## ORIGINATION FORM

### Proposed Revisions to a Standard Plans Index

Index Number: 700-030

Index Title: Wind and Hanger Beams for Overhead Signs

TYPICAL SIGN FOR OVERHEAD TRUSS

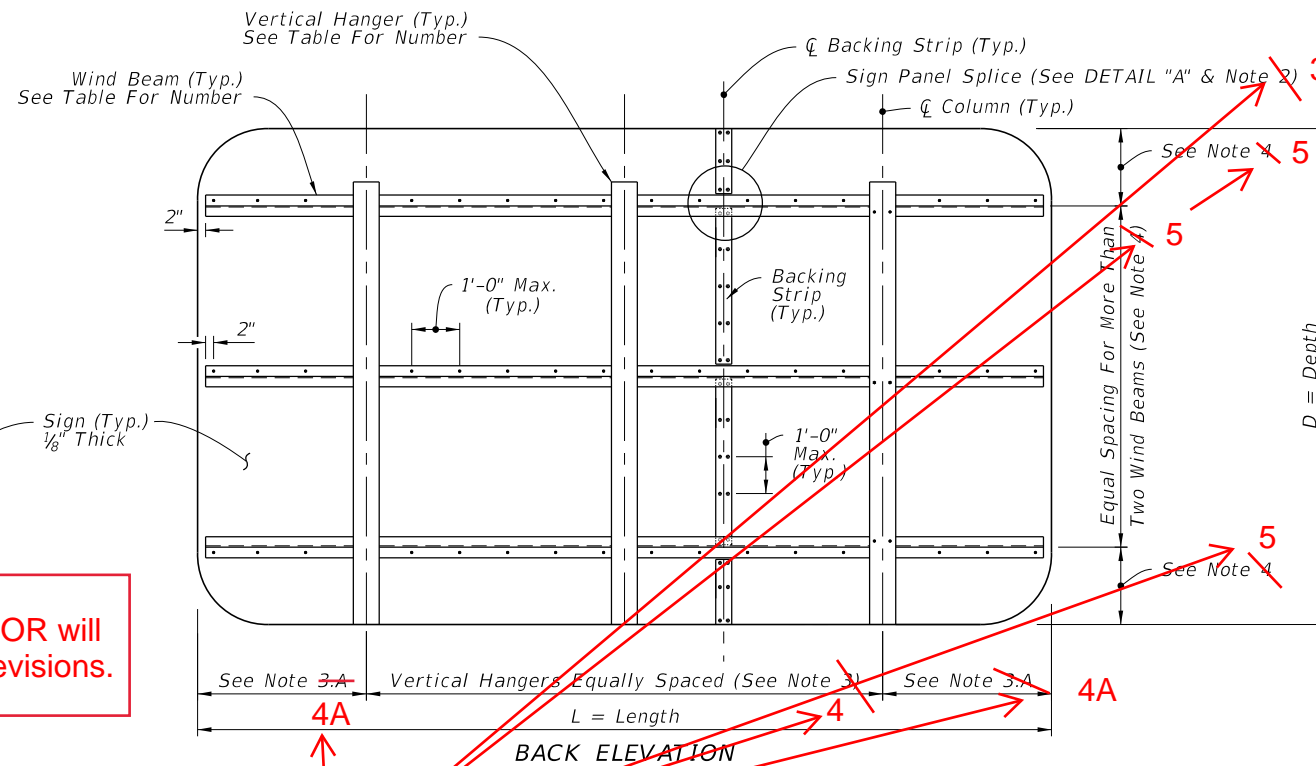
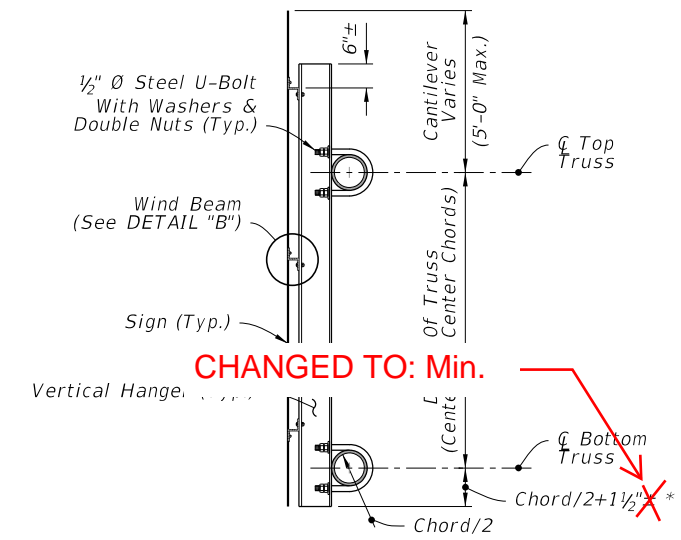
UPDATED: References (See General Note...)

ADDED NEW NOTE 1: Meet the requirements of Specification 700.

DETAIL "B"

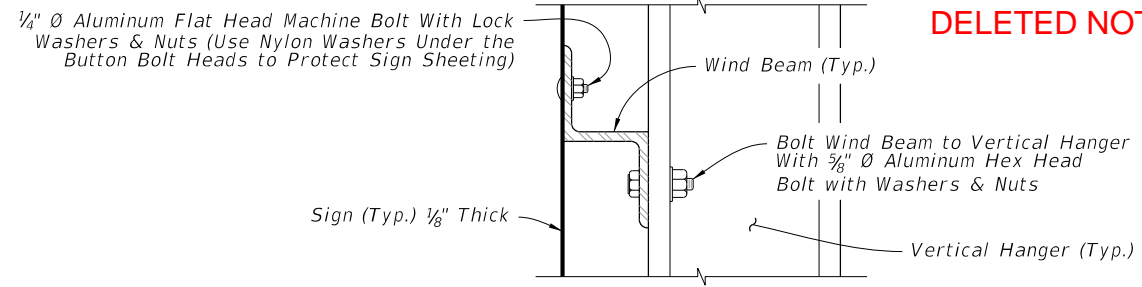
Added New General Note 1 - "Meet requirements of Specification 700."; Deleted Notes 6 and 7; Renumbered Notes; Updated General Note references in the TYPICAL SIGN FOR OVERHEAD TRUSS details; Changed the tolerance symbol "+/-" for the edge distance of the bottom U-bolt to a "Min."

A tolerance of +/- suggests that the 1 1/2" dimension could be less and by some undefined amount. While any additional edge distance would not be structurally significant we wanted to put a lower limit on the edge distance.
